Access Compliance Report

Public Rights-of-Way

(Pedestrian Signals)

Intersection ID: N/A	Main Street:	Cross Street: N/A	Location: N/A
ADA ID: E64A2ACF5D45	Signal Type: One Push Button-Non APS	Overall Compliance: No	Severity Score: BTN 1: N/A BTN 2: N/A No BTN: N/A
Codes/Mitigation Info/Possible Solution		Field Measurements/Component Compliance

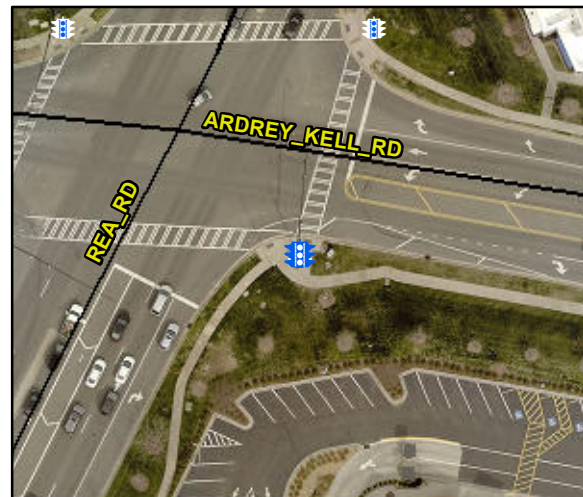
PROW/ADA: TMUTCD 4e.08, R404.2, R404.7.1, R404.7.2

Compliance	Description	Data	Compliance	Description	Data
	Button Count	Button1	N/A	Distant to Additional Button (in)	N/A
	Additional Button Present?	No		Additional Button ID	N/A
N/A	Signal Buttons Required?	N/A	N/A	Additional Ped Posts Required	N/A
	How Many Ped Street Xings?	2		Located In An Island/Median?	No
N/A	B 1 Sign Present?	Yes	N/A	B 2 Sign Present?	N/A
Yes	B 1 Sign Purpose?	Yes	N/A	B 2 Sign Purpose?	N/A
Yes	B 1 Sign Lettering & Contrast?	Yes	N/A	B 2 Sign Lettering & Contrast?	N/A
Yes	B 1 Parallel To XWalk?	Yes	N/A	B 2 Parallel To XWalk?	N/A
Yes	B 1 PAR to Button?	Yes	N/A	B 2 PAR to Button?	N/A
Yes	B 1 PAR to XWalk?	Yes	N/A	B 2 PAR to XWalk?	N/A
Yes	B 1 Clear Floor Space?	Yes	N/A	B 2 Clear Floor Space?	N/A
No	B 1 FWD Approach?	No	N/A	B 2 FWD Approach?	N/A
N/A	B 1 FWD Approach Constrained?	No	N/A	B 2 FWD Approach Constrained?	N/A
N/A	B 1 FWD Approach Reach (in)	16.0	N/A	B 2 FWD Approach Reach (in)	N/A

N/A	B 1 FWD Approach Width (in)	60.0	N/A	B 2 FWD Approach Width (in)	N/A
N/A	B 1 FWD Approach Obstruction?	Yes	N/A	B 2 FWD Approach Obstruction?	N/A
N/A	B 1 FWD Approach Obstruction Dist (in)	14.0	N/A	B 2 FWD Approach ObstructionDist (in)	N/A
No	B 1 PARA Approach?	No	N/A	B 2 PARA Approach?	N/A
N/A	B 1 PARA Approach Constrained?	No	N/A	B 2 PARA Approach Constrained?	N/A
N/A	B 1 PARA Approach Reach (in)	16.0	N/A	B 2 PARA Approach Reach (in)	N/A
N/A	B 1 PARA Approach Width (in)	60.0	N/A	B 2 PARA Approach Width (in)	N/A
N/A	B 1 PARA Approach Obstruction?	Yes	N/A	B 2 PARA Approach Obstruction?	N/A
N/A	B 1 PARA Approach Obstruction Dist (in)	14.0	N/A	B 2 PARA Approach ObstructionDist (in)	N/A
Yes	B 1 Clear Floor Space Slope (%)	0.3	N/A	B 2 Clear Floor Space Slope (%)	N/A
No	B 1 Clear Floor Space XSlope (%)	3.3	N/A	B 2 Clear Floor Space XSlope (%)	N/A
N/A	B 1 PAR Slope (%)	0.0	N/A	B 2 PAR Slope (%)	N/A
Yes	B 1 Height (in)	35.0	N/A	B 2 Height (in)	N/A

Yes	B 1 Clear Xing Direction?	ClearlyMarked	N/A	B 2 Clear Xing Direction?	N/A
	B 1 Crossing Direction	To W		B 2 Crossing Direction	N/A
Yes	B 1 DistanceTo XWalk (in)	0.0	N/A	B 2 DistanceTo XWalk (in)	N/A
No	B 1 DistanceTo Curb (in)	90.0	N/A	B 2 DistanceTo Curb (in)	N/A
Yes	B 1 Diameter (in)	2.0	N/A	B 2 Diameter (in)	N/A

Possible Solutions: Replace Signal Push Button With APS Button on New Post. Remove & Relocate Sign.
